JVC Service Bulletin

SUBJECT: Display "Upgrade Disc" and hanged up

DATE : 13.07.2006

RE: MX-DK1/15/3 & CA-MXDK5/51 SERIES SET HANG-UP RECOVERY PROCEDURE

1. Change R3101 from NRSA63J-103X to NRSA63J-222X. Refer to picture below for location.

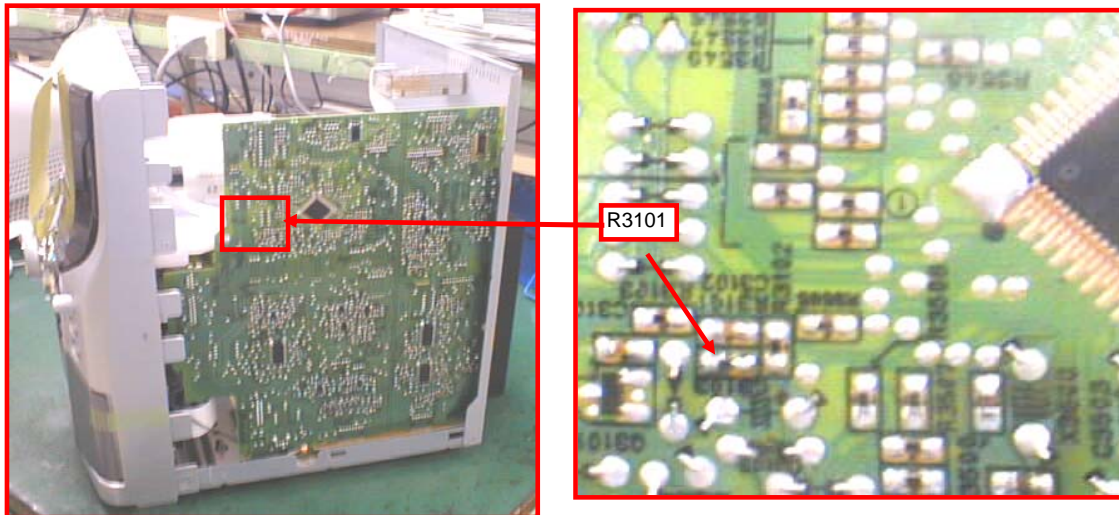
Reasons: Programing bug

Cure: Change R3103 values from 10K to 2.2K and upgrade software.

Model	Symbol NO.	Before	After
MX-DK1/15/3/51/5	R3103	NRSA63J-103X	NRSA63J-222X

FOR MODEL MX-DK1 / MX-DK15 / MX-DK3 AND CA-MXDK5 ONLY
(GVA10121-A1)

FOR MODEL CA-MXDK51 ONLY
(GVA10122-A1)
